RESPONSES TO NRC REQUESTS
DATED APRIL 22, 1977, FOR ADDITIONAL
INFORMATION REGARDING THE PROPOSED COOLING
SYSTEM DESIGN CHANGE

DOCKET NO. 50-410

NINE MILE POINT NUCLEAR STATION - UNIT 2
NIAGARA MOHAWK POWER CORPORATION

SEPTEMBER 30, 1977

FIGURE RI5-1
 NO. 1 INTAKE TUNNEL & DIFFUSER
 NINE MILE POINT NUCLEAR STATION - UNIT 2
 NIAGARA MOHAWK POWER CORPORATION

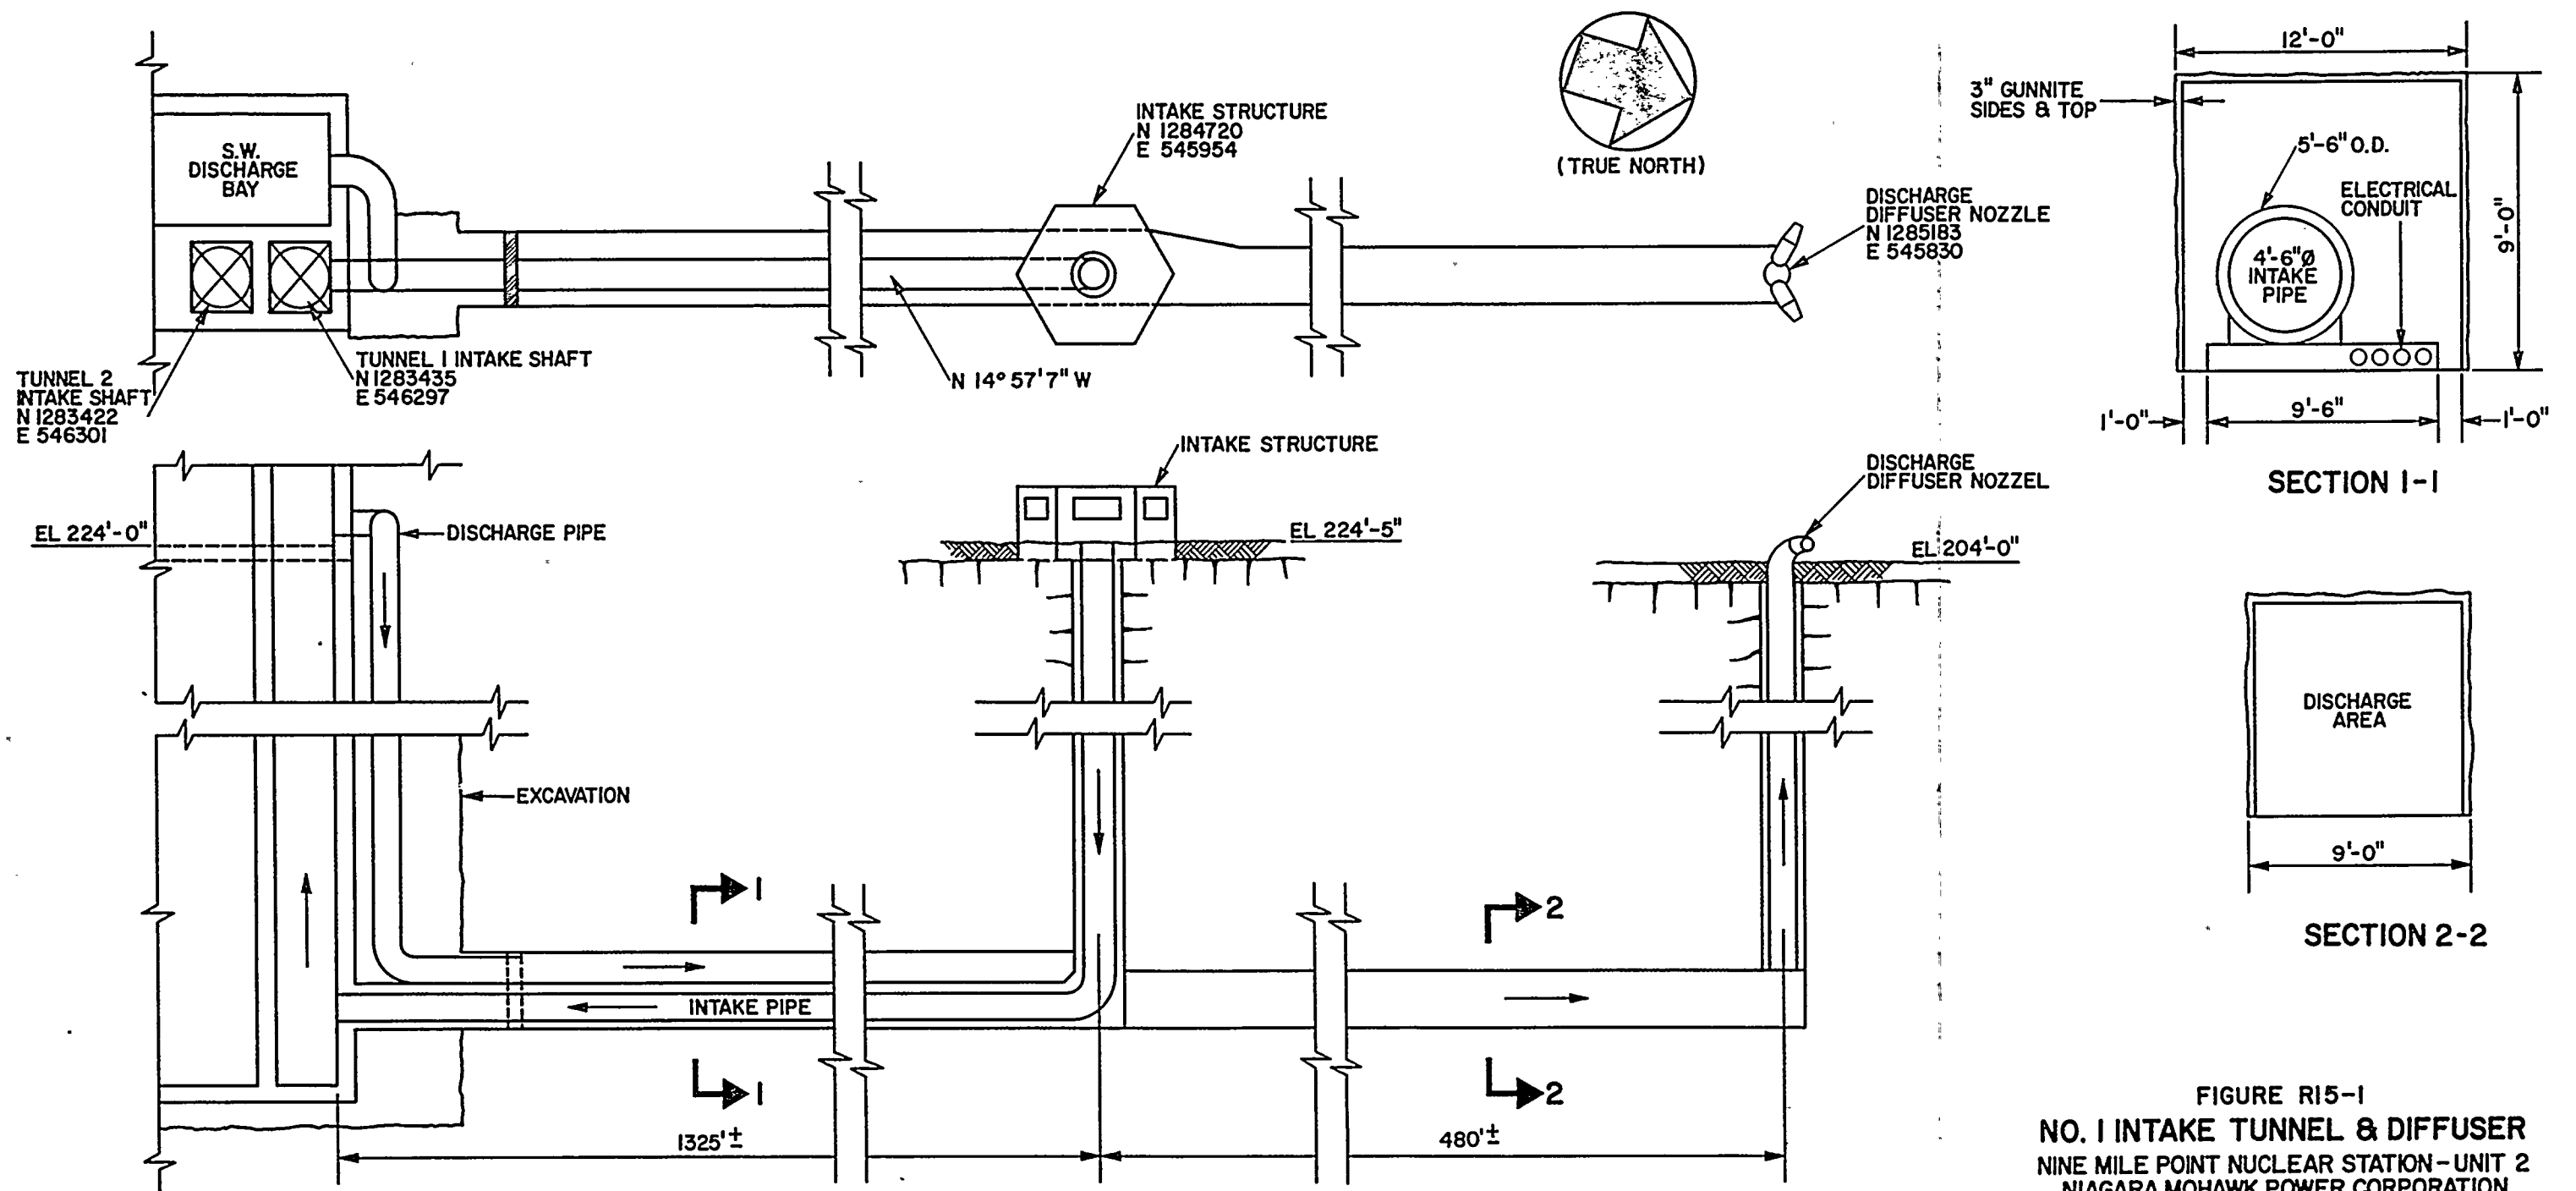
Accordingly, document that the ultimate heat sink complex has sufficient redundancy to withstand the above single failures. Provide the seismic capability of the various structures, and document that the system meets the criteria suggested in Reg. Guide 1.27. Provide information regarding the conceptual design of the proposed system including sections, plans, and drawings of sufficient detail to show the locations, elevations, and features of the various structures of the system.

The lake discharge system will consist of a screenwell discharge bay, a discharge area within the west tunnel, a single riser, and a two-nozzle diffuser located approximately 1500 ft offshore. The profile of the discharge system is shown on Figure R15-1. The discharge bay will be connected to the west tunnel, Tunnel 1 on Figure R15-1, by a 4.5 ft diameter steel pipe. The flow will pass through the tunnel into a single riser and will be discharged from the two nozzles to the lake. The location of the diffuser nozzles is shown on Figure R11-1.
